DATE: **May 23, 2025**

PROJECT NAME: **LXT General Aviation Terminal  
Lee's Summit City Project #17932172**

ADDENDUM No. **1**

**3. Clarification - E-120 SPECIAL SYSTEMS PLAN**

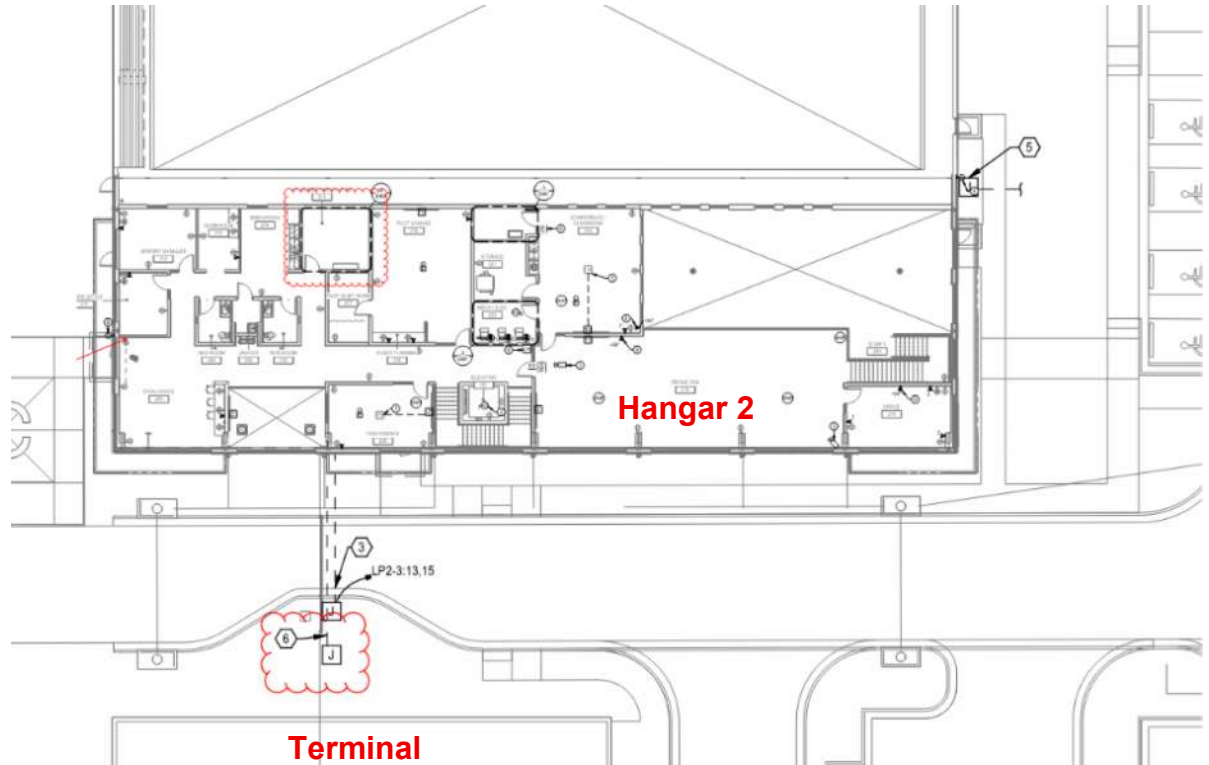
- a. **CLARIFY** all televisions shown on this sheet and AV sheets shall receive CAT-6 only per details; no coaxial cabling at televisions.

**A-401**  
SHEET OF

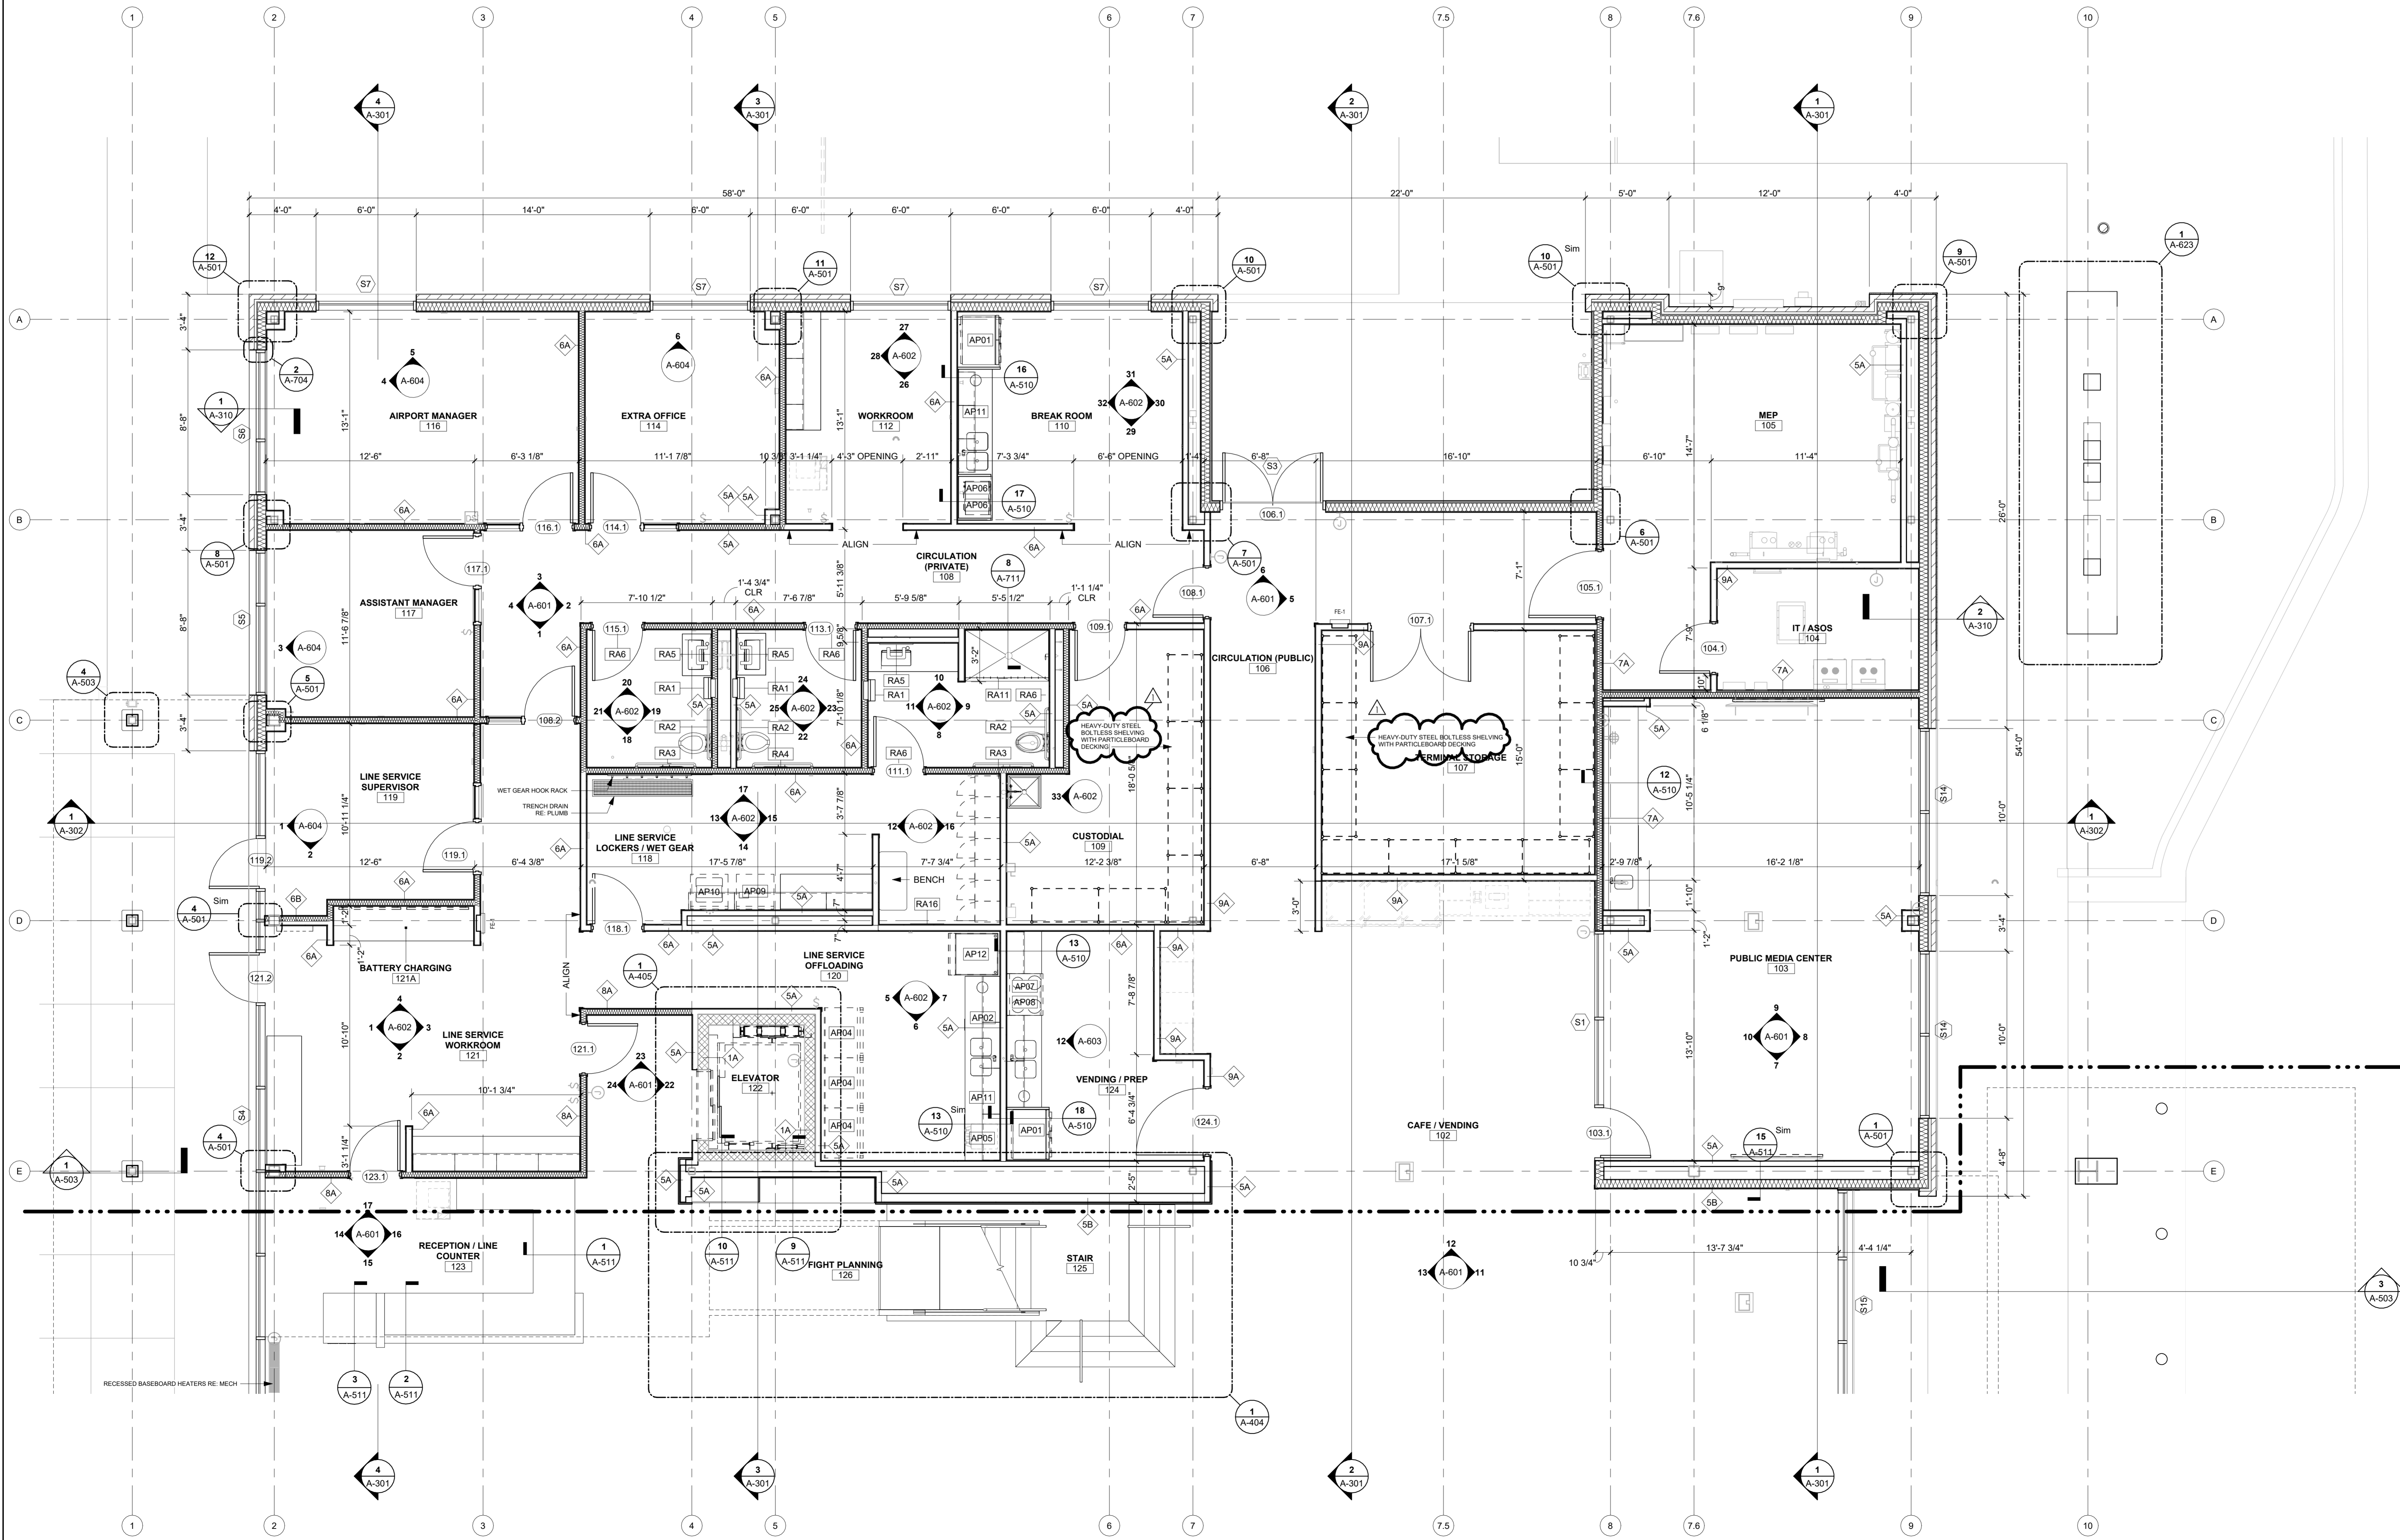
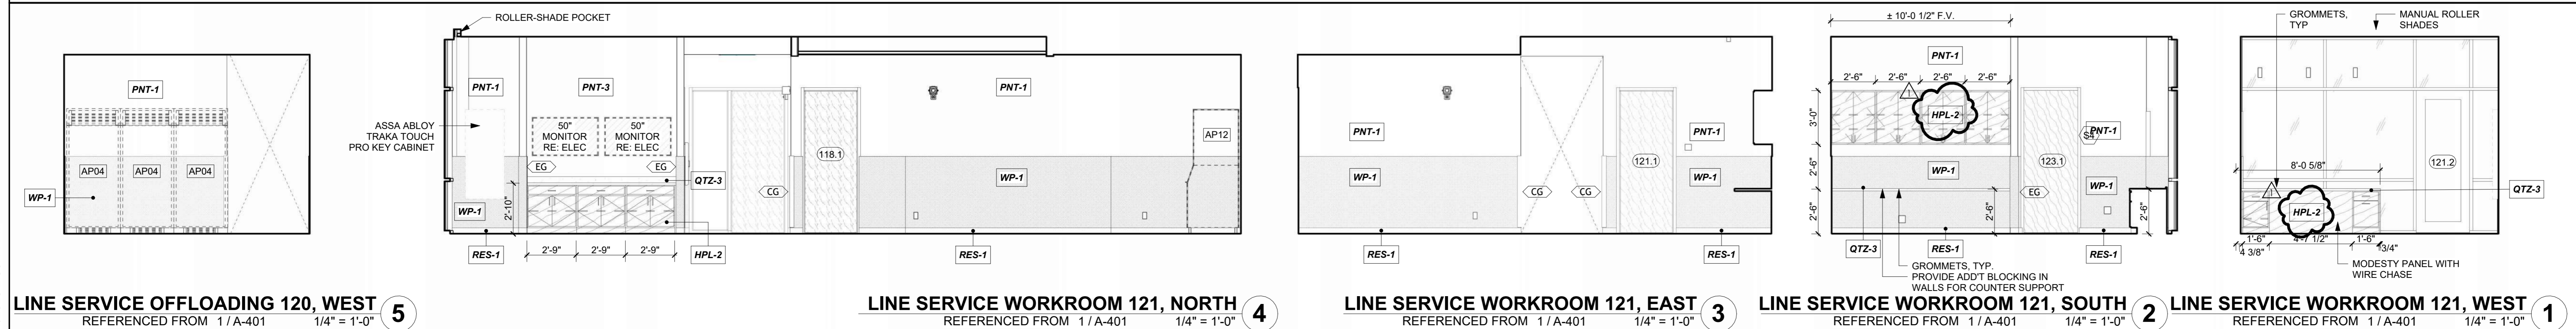
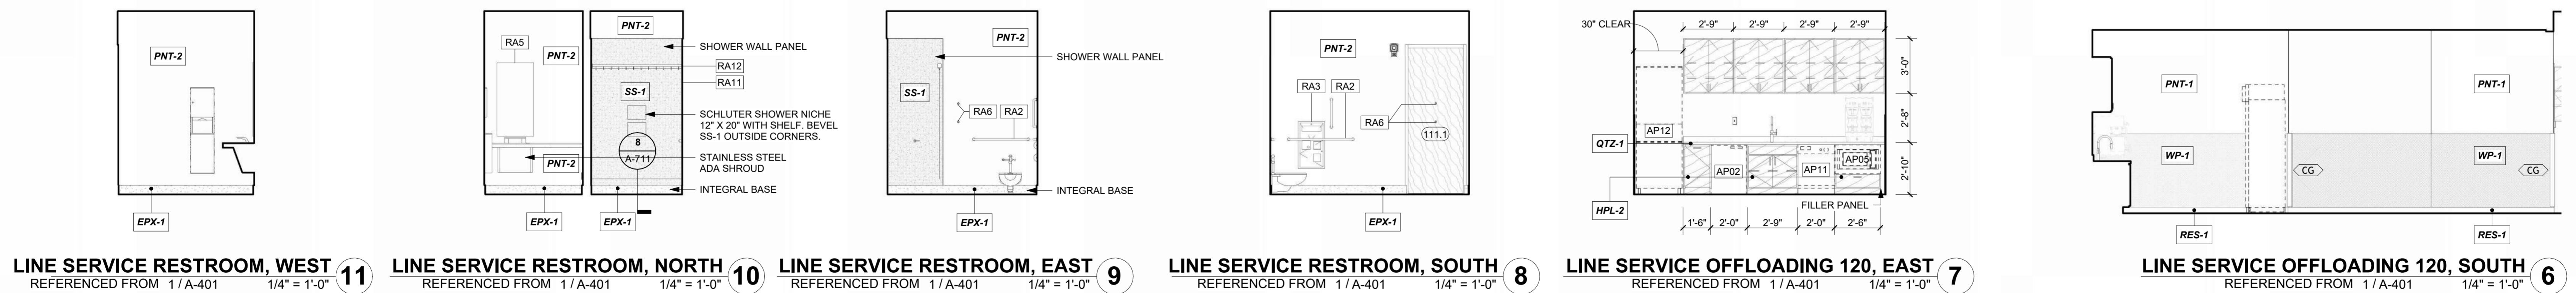
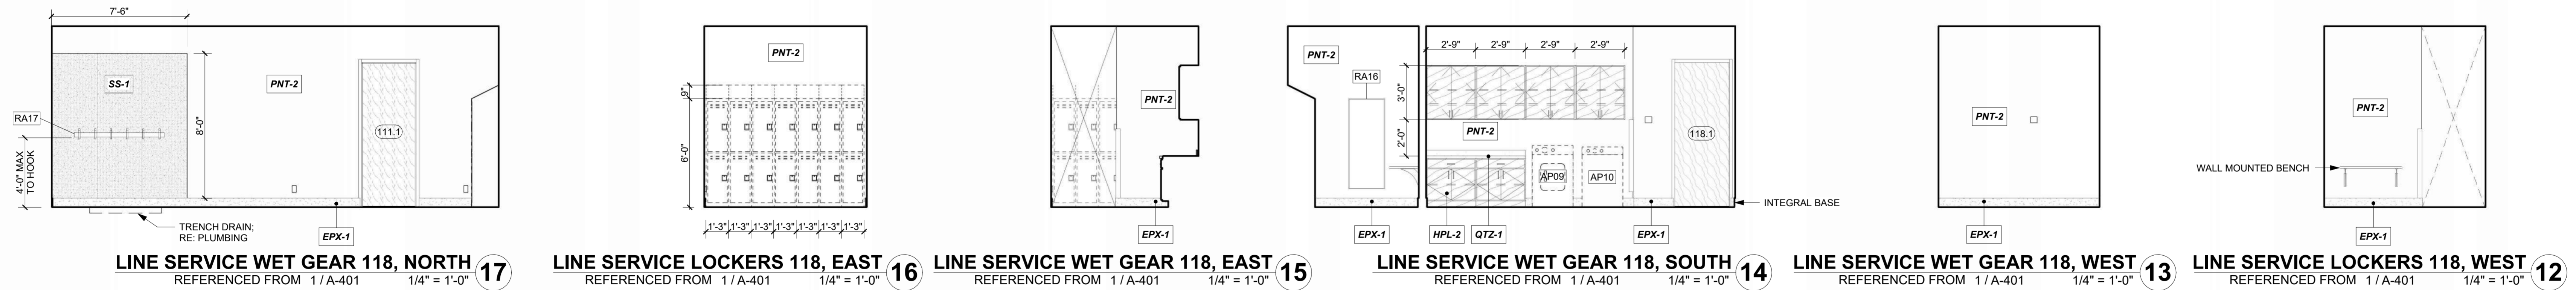
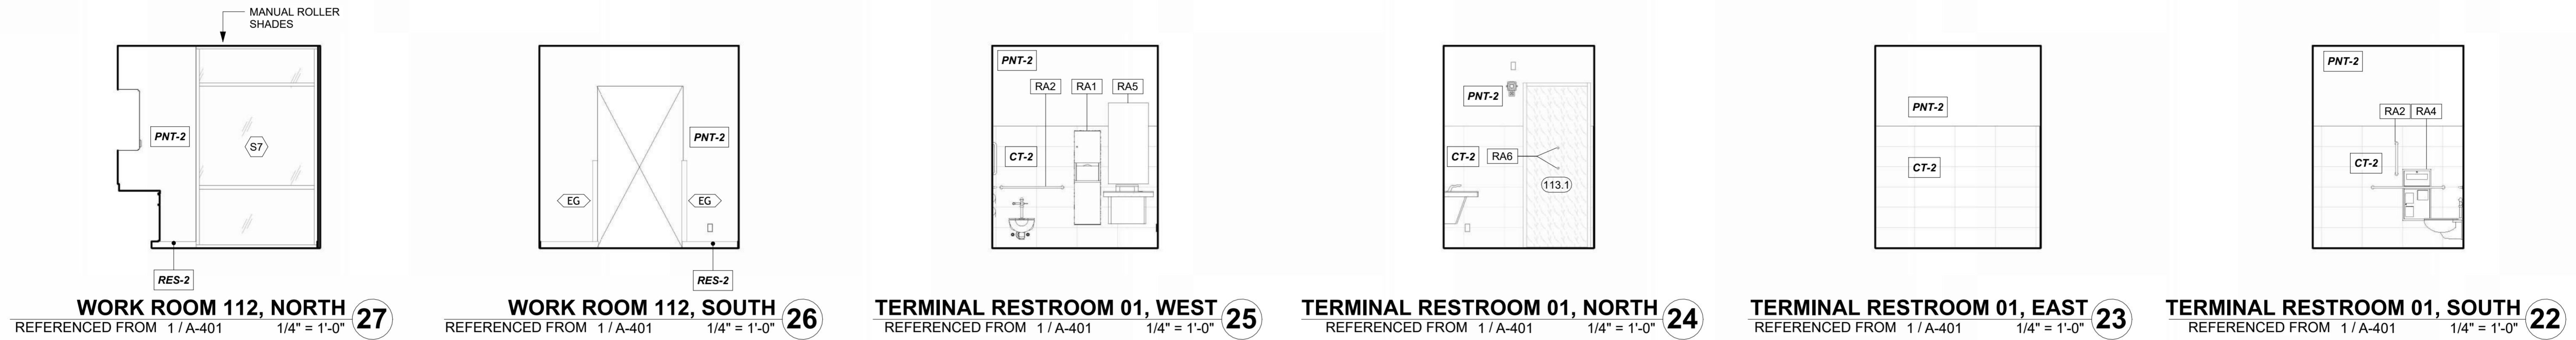
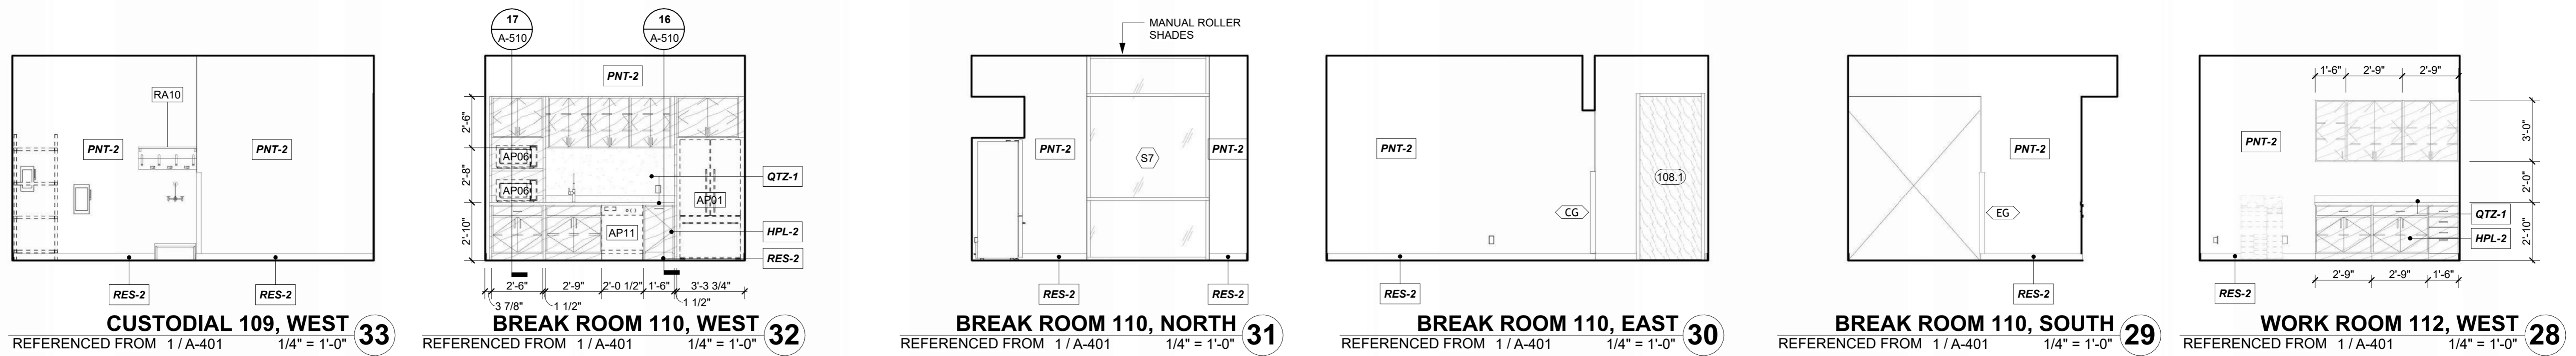
**1. A-401 ENLARGED 1ST FLOOR PLAN - NORTH**

- a. **REVISE** note to shelving HEAVY-DUTY STEEL BOLTLESS SHELVING WITH PARTICLEBOARD DECKING.
